STAFF REPORT
COMMUNITY DEVELOPMENT DEPARTMENT

SUBJECT: H-2021-0016
1450 W. Ustick MDA

Development Agreement Modification to amend the Sugarman Subdivision Development Agreement (Inst. #2014-088000) to replace the existing concept plan with the submitted development plan, by Mark Bigelow, MRS Landholdings.

B. Existing DA Concept Plan:

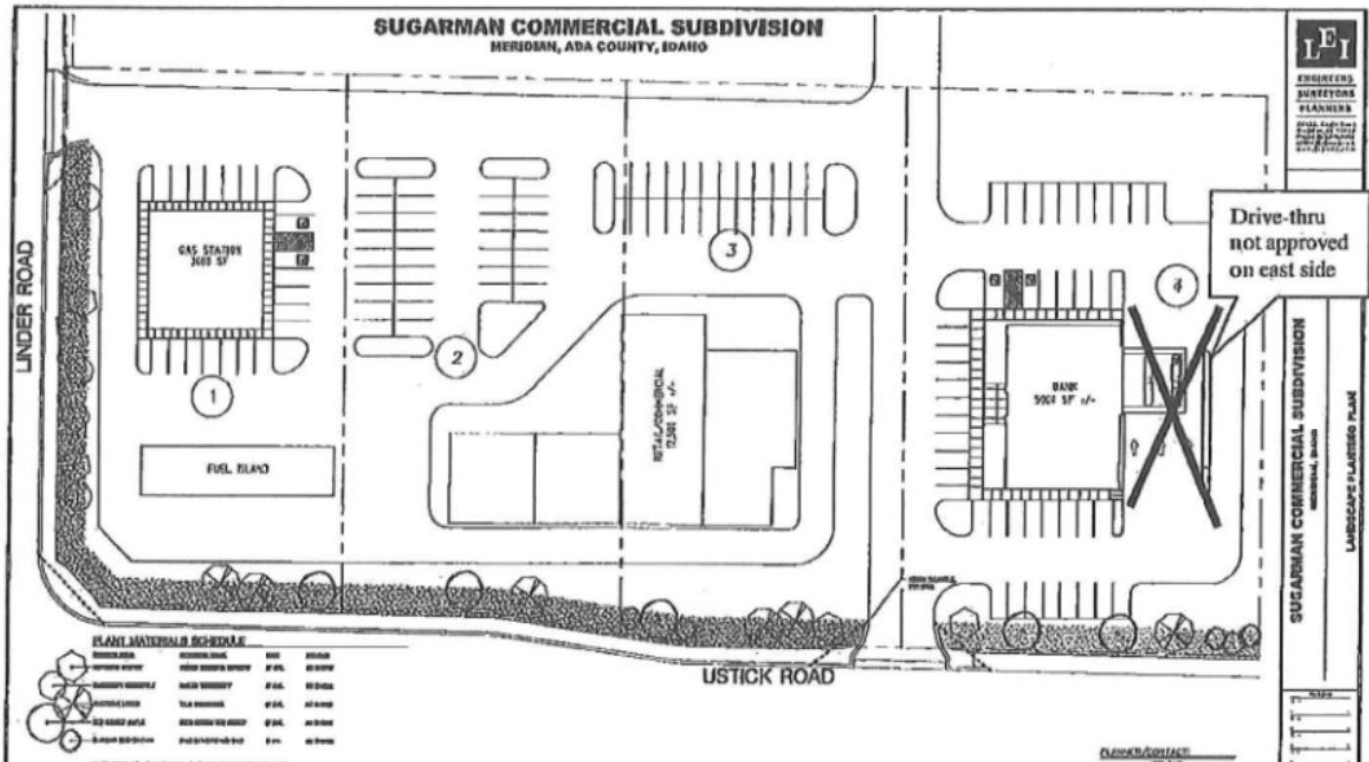
Concept Plan: The concept plan in the existing DA depicts 3 buildings; a gas station, a multi-tenant building, and a bank with a drive-through. The existing DA restricted the location of the drive-through through the hearing process. In addition, the existing concept plan shows a connection to the north directly in line with the Ustick Road access and shows a restricted access point to Linder Road. See Exhibit B for the existing concept plan.

Access: Despite the existing access points being approved with the original approvals and concept plan in 2014, the adjacent property to the north has received plat approval and includes a public road stub on the subject site's northern boundary that was not part of the original approvals. The submitted concept plan shows the public road terminating on site via the commercial drive aisles requiring a public access easement on this property. This is not consistent with ACHD policy and requires the road to terminate in a cul-de-sac unless the applicant requests a waiver to this policy which may require ACHD Commission action. Per ACHD staff, this waiver cannot be requested until a future CZC application is submitted for review and approval. ACHD does not provide action or conditions of approval on development agreement applications. If the applicant does not obtain the waiver, it does affect the design of the proposed concept plan and would require a redesign to accommodate a cul-de-sac. A recommended DA provision requires compliance with ACHD policy. This would allow the applicant to move forward with executing the amended DA and submitting a CZC application for ACHD to review and provide the necessary determination on the extension of the approved stub street and access to Ustick Road.

Furthermore, the access to Linder shown on the submitted site plan does not meet ACHD offset policy nor UDC 11-3A-3. This access point should be closed with the future CZC application submittal. The need for this access is further mitigated with an access through Edington Commons to the north that leads to a safer access to Linder Road. The closure of the Linder access on this site also furthers the integration of this site with the residential to the north which helps the project meet the integration desired on mixed-use properties like this.

5.1.1: "N. Linder Road access is prohibited in accord with UDC 11-3A-3. Access to W. Ustick Road shall be restricted to right-in/right-out only.

5.1.2: "Future development of this site shall be generally consistent the conceptual development plan and building elevations shown on the landscape plan in Exhibit V.C., ~~except for the drive-thru shall be relocated (if proposed) internally and not be located along the east or north boundaries of the site adjacent to existing and future residential properties.~~"

Add provision: "Applicant shall extend the public road from Edington Commons (Parcel #S0436336054) into the subject site per ACHD policy."
